Application for Licence Amendment

Part V Division 3 of the *Environmental Protection Act 1986*

Licence Number	L4503/1975/14
Licence Holder	BHP Iron Ore Pty Ltd
ACN	008 700 981
File Number	DWERVT15779~1
Premises	<p>Mt Whaleback/Orebody 29/30/35 and Western Ridge NEWMAN WA 6753</p> <p>Legal description – Tenements E52/2009-I, ML244SA, ML244SA, ML266SA, G52/019-G52/256, G52/258-G52/274, G52/276, G52/277, G52/279, L47/92, L52/99, L52/185, L52/199, K858923 and N088235</p> <p>As defined by the premises map in Schedule 1 and defined by the coordinates in Schedule 2</p>
Date of Report	7 April 2025
Decision	Revised licence granted

Figure 3: Dust exceedances ($\geq 70 \text{ ug/m}^3$) values attributed to BHP operations per financial year

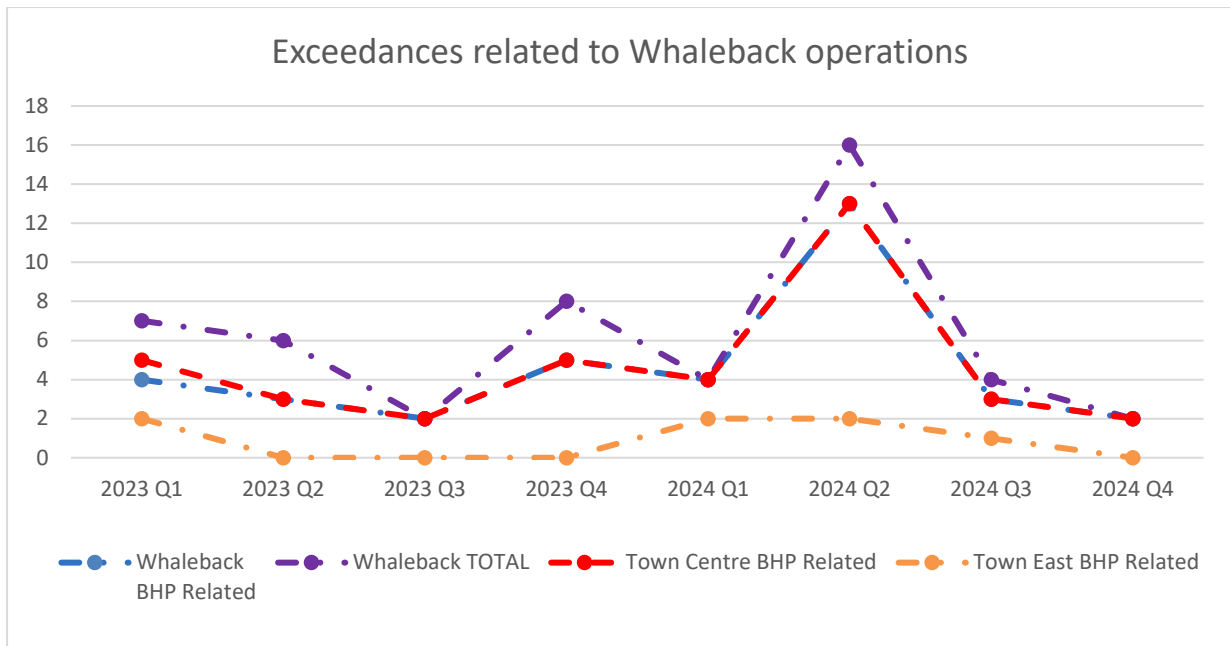
AR Section 3.3.2, Figure 3	The Licence Holder has requested clarifications on the information provided in this figure, particularly which whaleback monitor is being referred to, and whether the date reference is for calendar or financial year.	
Comments received 7 April 2025	Minor clarifications and suggested edits to typographical errors.	Updated as required.
